ECE/TRANS/WP.29/GRE/2009/45  
16 July 2009

COLLECTIVE AMENDMENTS

Proposal for draft 01 series of amendments to Regulation No. 98  
(Headlamps with gas-discharge light sources)

Submitted by the expert from the Working Party "Brussels 1952" \*/

**Figure A: Spherical coordinate measuring system**

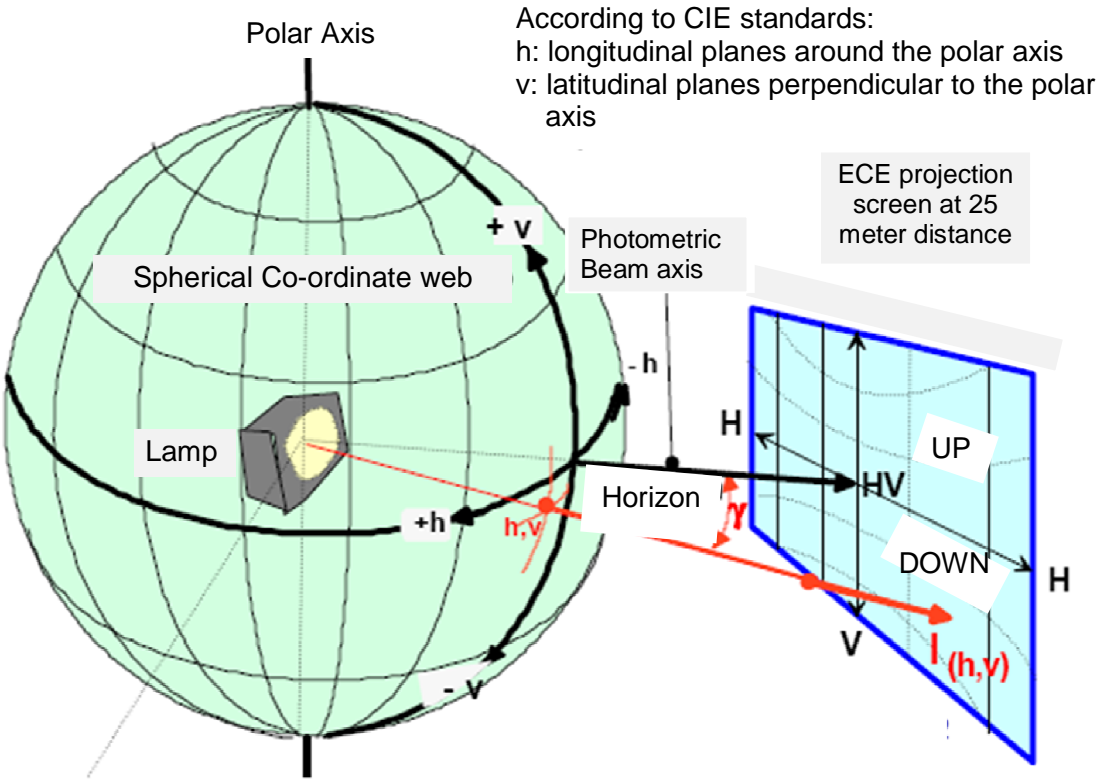
"6.1.2. **The luminous intensity produced by the headlamp shall be measured at 25 m distance by means of a photoelectric cell having a useful area comprised within a square of 65 mm side. The point HV is the centre-point of the coordinate system with a vertical polar axis. Line h is the horizontal through HV (see Annex 3 to this Regulation).**"

Annex 3, amend to read:

**SPHERICAL COORDINATE MEASURING SYSTEM  
AND TEST POINT LOCATIONS**

$$E_{25m} = I_{(h,v)} \times \cos \gamma / r^2$$

**Figure B: Passing beam for right-hand traffic**

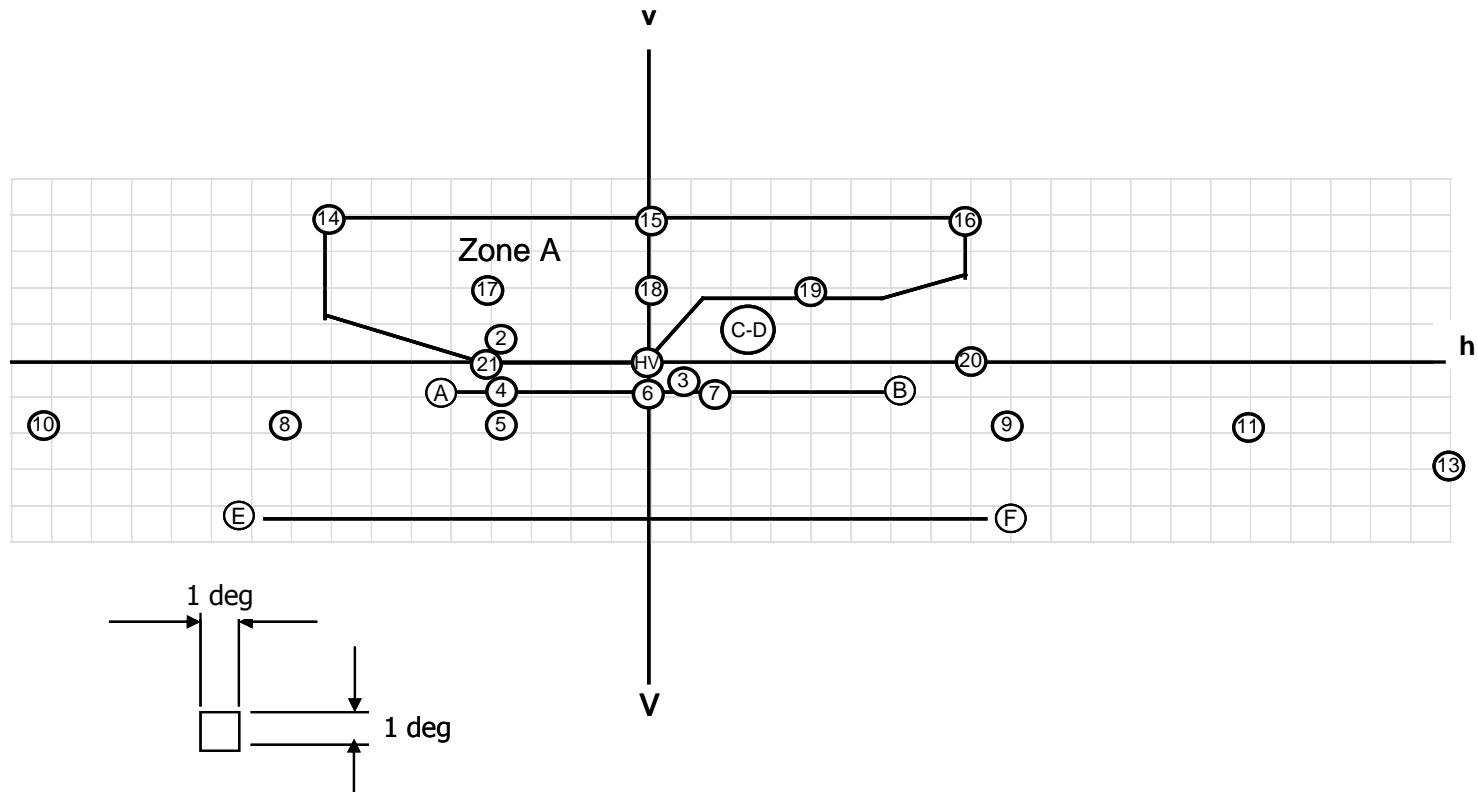
"6.2.5. After more than 10 minutes after ignition the ~~illuminances~~ **luminous intensities at the test points referred to in the table below and in Annex 3 figure B** (or mirrored about the VV line for left-hand traffic) shall meet the following requirements:

**h-h = horizontal plane , v-v = vertical plane passing through the optical axis of the headlamp**

**The test point locations for left-hand traffic are mirrored about the VV line**

Points or segments	Designation <b>**/</b>	Luminous Intensity (cd)		Horizontal Angle (Degrees)	Vertical Angle (Degrees)						
		Max	Min								
Any point in zone A (bounded by the following coordinates in degrees)											
8L	8L	8R	8R	6R	1.5R	V-V	4L	<b>625</b>			
1U	4U	4U	2U	1.5U	1.5U	H-H	H-H				
1	HV						<b>625</b>		<b>0</b>	<b>0</b>	
2	B 50 L						<b>315</b>		<b>3.43 L</b>	<b>0.57 U</b>	
3	75 R							<b>12500</b>	<b>1.15 R</b>	<b>0.57 D</b>	
4	50 L						<b>12500</b>		<b>3.43 L</b>	<b>0.86 D</b>	
5	25 L1						<b>18800</b>		<b>3.43 L</b>	<b>1.72 D</b>	
6	50 V							<b>7500</b>	<b>0</b>	<b>0.86 D</b>	
7	50 R							<b>12500</b>	<b>1.72 R</b>	<b>0.86 D</b>	
8	25 L2							<b>2500</b>	<b>9 L</b>	<b>1.72 D</b>	
9	25 R1							<b>2500</b>	<b>9 R</b>	<b>1.72 D</b>	
10	25 L3							<b>1250</b>	<b>15 L</b>	<b>1.72 D</b>	
11	25 R2							<b>1250</b>	<b>15 R</b>	<b>1.72 D</b>	
12	15 L							<b>625</b>	<b>20L</b>	<b>2.86 D</b>

13	15 R							<b>625</b>	<b>20R</b>	<b>2.86 D</b>	
14								<b>*/</b>	<b>8L</b>	<b>4 U</b>	
15								<b>*/</b>	<b>0</b>	<b>4 U</b>	
16								<b>*/</b>	<b>8 R</b>	<b>4 U</b>	
17								<b>*/</b>	<b>4 L</b>	<b>2 U</b>	
18								<b>*/</b>	<b>0</b>	<b>2 U</b>	
19								<b>*/</b>	<b>4 R</b>	<b>2 U</b>	
20								<b>65</b>	<b>8 R</b>	<b>0</b>	
21								<b>125</b>	<b>4 L</b>	<b>0</b>	
A to B	Segment I							<b>3750</b>	<b>5.15 L to 5.15 R</b>	<b>0.86 D</b>	
C - D							<b>1750</b>		<b>2.5 R</b>	<b>1 U</b>	
E to F	Segment III and under						<b>12500</b>		<b>9.37 L to 8.53 R</b>	<b>4.29 D</b>	
	E max R						<b>43800</b>		<b>Right of VV line</b>	<b>Above 1.72 D</b>	
	E max L						<b>31300</b>		<b>Left of VV line</b>

**Figure C: Driving beam test points**

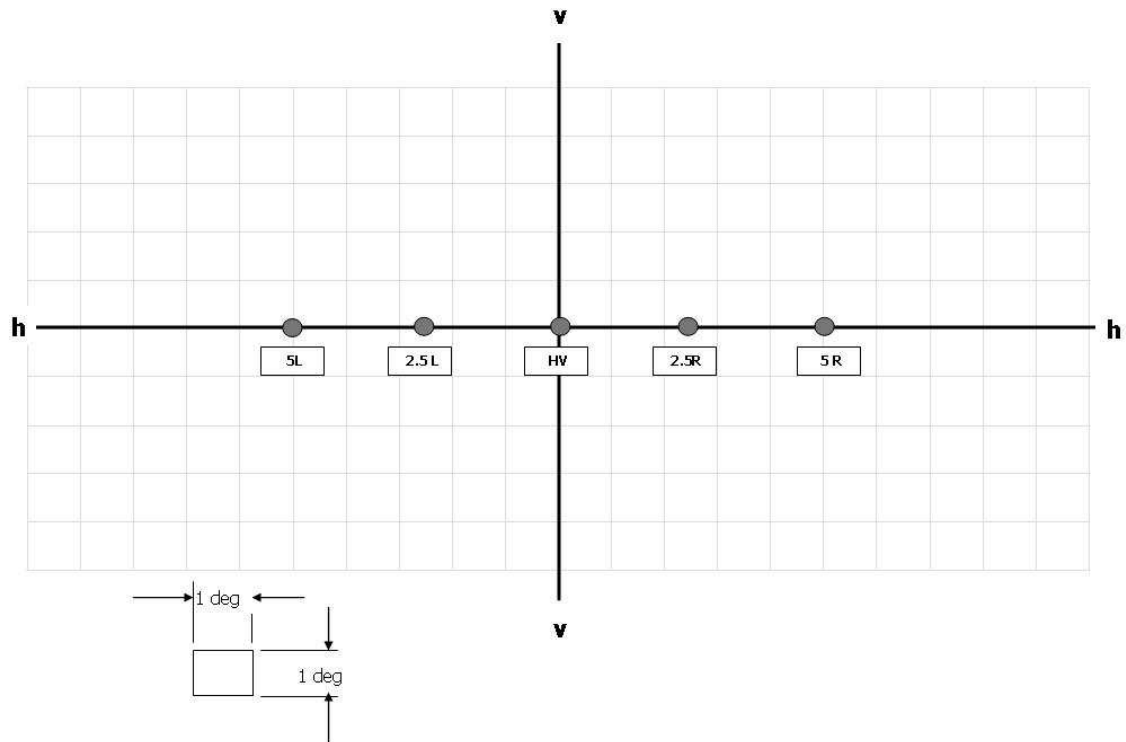
"6.3.3. Referring to Annex 3 Figure C, and the table below, the luminous intensity distribution of the driving beam shall meet the following requirements.

**h-h = horizontal plane , v-v = vertical plane passing through the optical axis of the headlamp**

Test Point	Angular Coordinates Degrees	Required luminous intensity cd
		Min
H-5L	0.0 , 5.0 L	6250
H-2.5L	0.0 , 2.5 L	25000
H-2.5R	0.0 , 2.5 R	25000
H-5R	0.0 , 5.0 R	6250

6.3.3.1. The point of intersection (HV) of lines HH and VV shall be situated within the isolux representing 80 per cent of maximum luminous intensity. **This maximum value ( $I_M$ ) shall not be less than 43800 cd.**
